Pleasanton Unified School District	ADDENDUM 02
	Project: Lydiksen Elementary School Modernization (2021-22.14)
	Date: April 20, 2022

Subject: Lydiksen Elementary School Modernization
Pleasanton School District
Aedis Project No. 2020029.02
DSA Application #01-119816

ADDENDUM NO. 2

AD2-E1.1

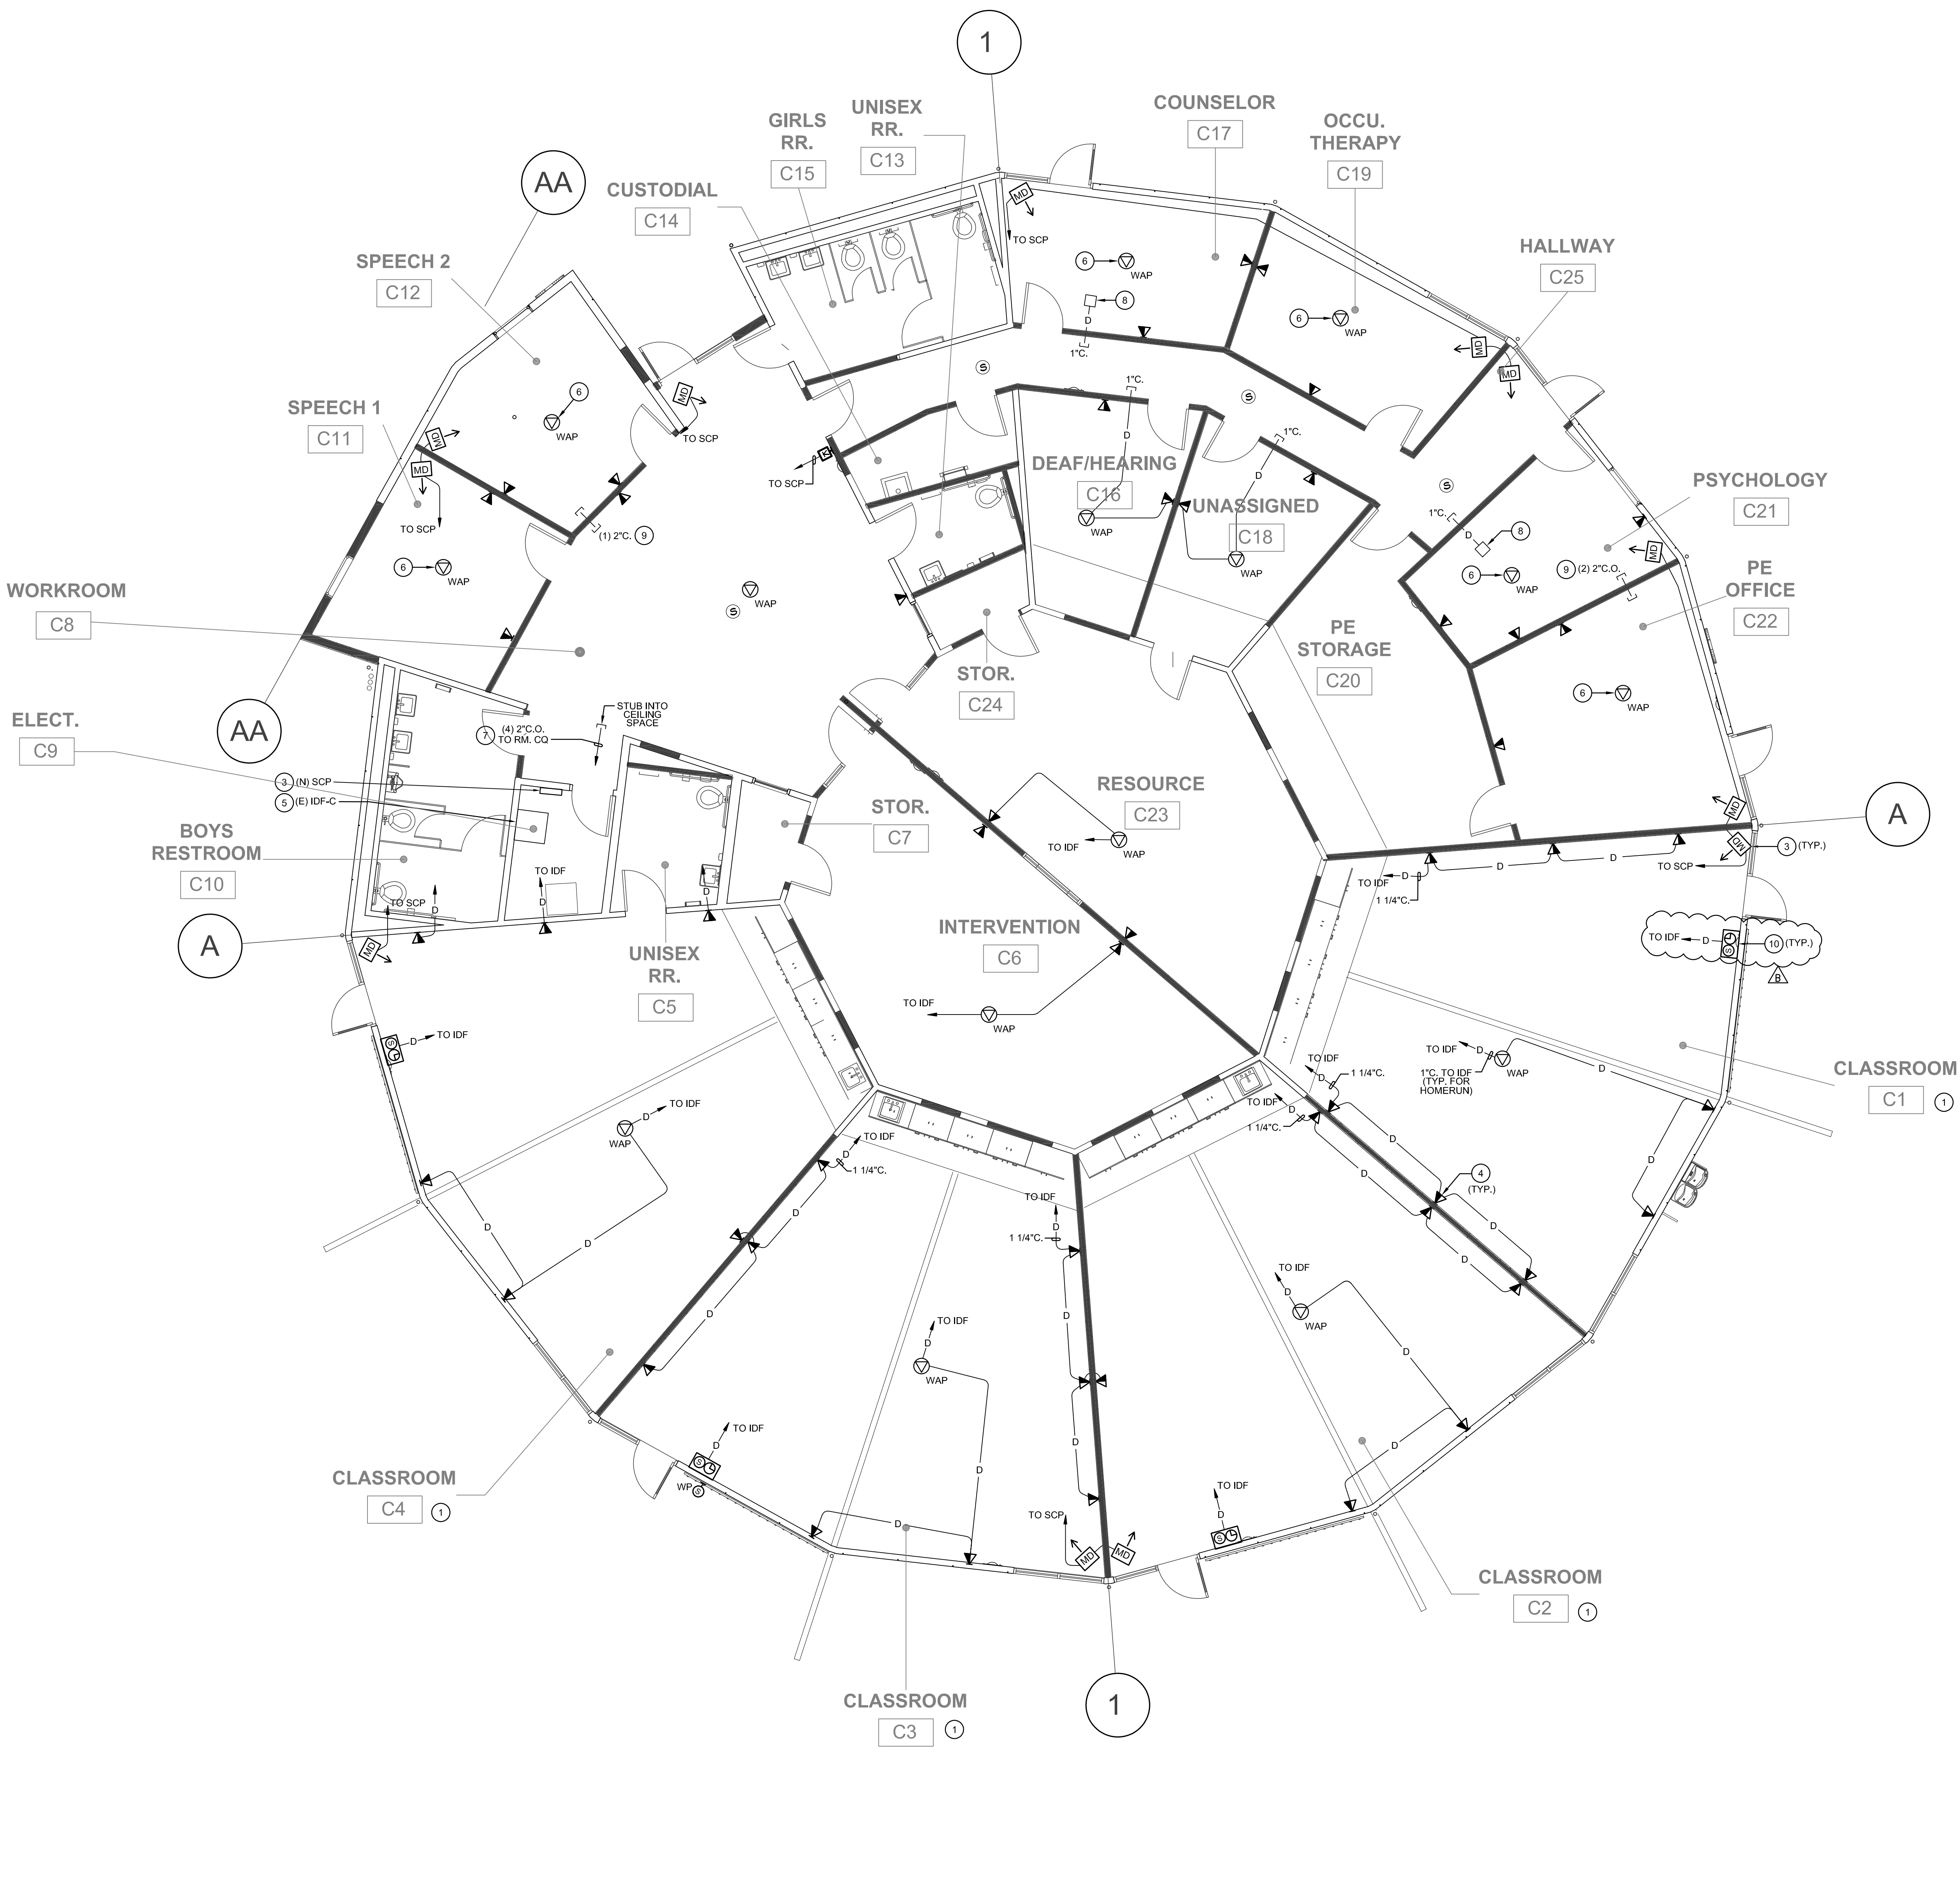
ITEM NO. 2.7: DRAWING SHEET E1.1 – ELECTRICAL SITE PLAN

Add: Receptacles at each pole of shade structure per attached AD2-E1.1

DATE 10/21/2021
JOB # 2020029.02
SHEET # AD2-
EC2.2

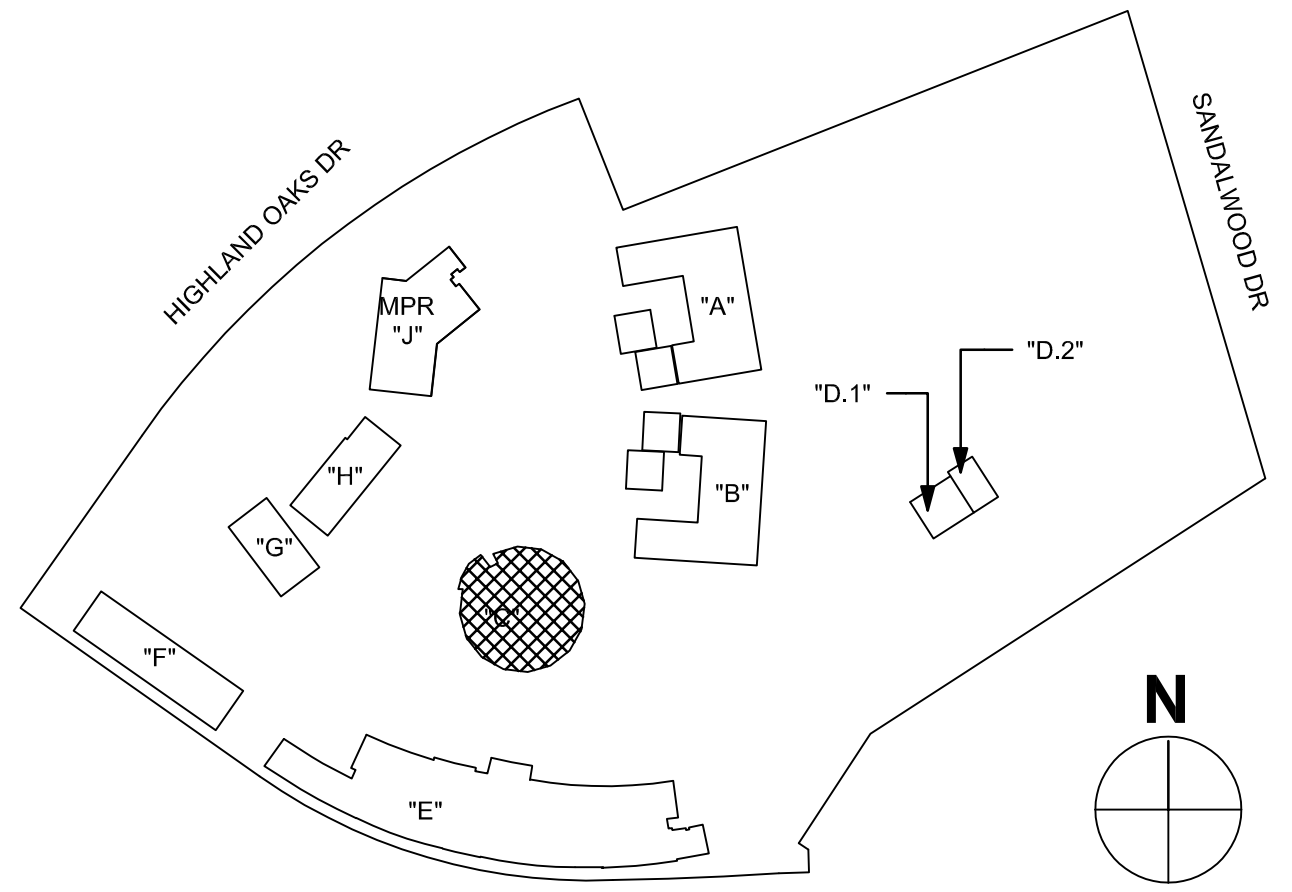
ITEM NO. 2.8: DRAWING SHEET EC2.2 – SIGNAL – BUILDING C – NEW FLOOR PLAN

Revise: Construction Keynote #10 - per attached AD2-EC2.2
